NEF: #03-002

Subject: Louisiana Energy Services Gas Centrifuge Uranium Enrichment Facility
Response to NRC Request for Information
NRC Docket No. 70-3103

NRC Letter dated March 25, 2003, "Request for Additional Information on the Louisiana Energy Services Quality Assurance Program Description, Revision 0, Dated November 26, 2002," transmitted a Request for Additional Information (RAI) resulting from the NRC's technical review of the Louisiana Energy Services (LES) Quality Assurance Program Description (QAPD) submitted to the NRC by letter dated November 26, 2002. This RAI reflects the additional information or clarification identified by the NRC that is needed to determine the acceptability of the QAPD for the design, construction, operation, and decommissioning of the gas centrifuge uranium enrichment facility to be proposed by LES. LES's responses to the questions in the RAI are provided below, including a reiteration of the NRC questions for completeness.

Figure A1 LES Corporate, Design and Construction Organization

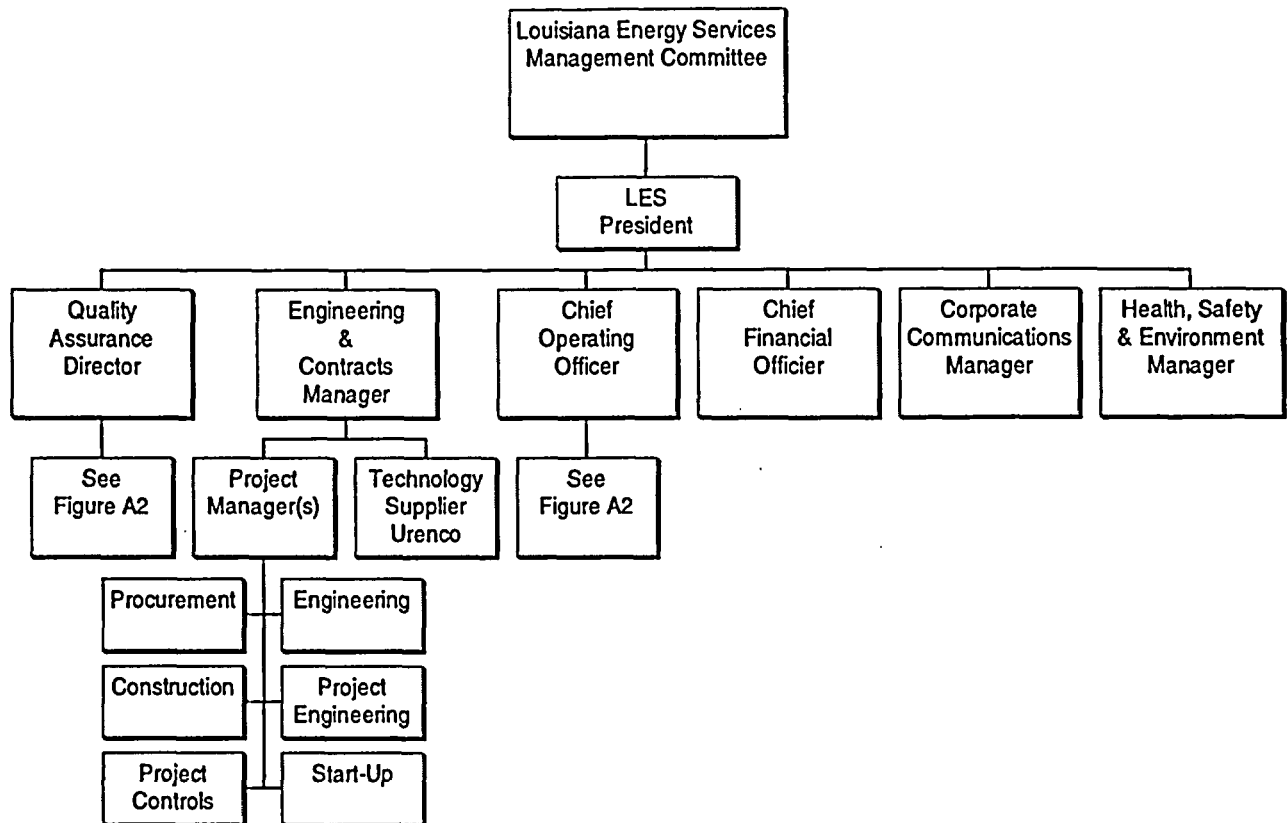
NRC Request: 2a. Describe clearly how the design engineering, construction, safety, and QA functions and organizations report and interface within LES, and how activities are controlled by the QAPD.

- NRC Request: 2f. Identify and explain the functions and responsibilities of the QA organization responsible for review and oversight of the Integrated Safety Analysis process, the structures, systems, and component (SSC) IROFS Quality Levels categorization process and determinations, for establishing the QA controls to provide adequate assurance of IROFS performance, and for verification of the design bases.

Response: The description of how the design engineering, construction, safety, and QA functions and how organizations report and interface with LES provided in the original QAPD have been expanded and clarified. The revised QAPD now delineates the following specific subsections:

Response: The information provided in the original QAPD explaining the LES organization has been amplified. The revised QAPD now delineates and explains the interfaces between LES and the centrifuge technology provider Urenco Ltd, the architect/engineer and contractors who perform the initial site evaluation, safety and environmental analyses and construction. The revised QAPD contains an expanded discussion of the reporting relationship between the QA functions during the design and construction phases and the startup testing and operations phases. Within this reporting relationship the responsibilities for design control/configuration management, inspection, quality control, procurement, receipt inspection, and document and records control are clearly delineated. The revised QAPD clarifies the QA organization responsibilities for applying specific QA controls.
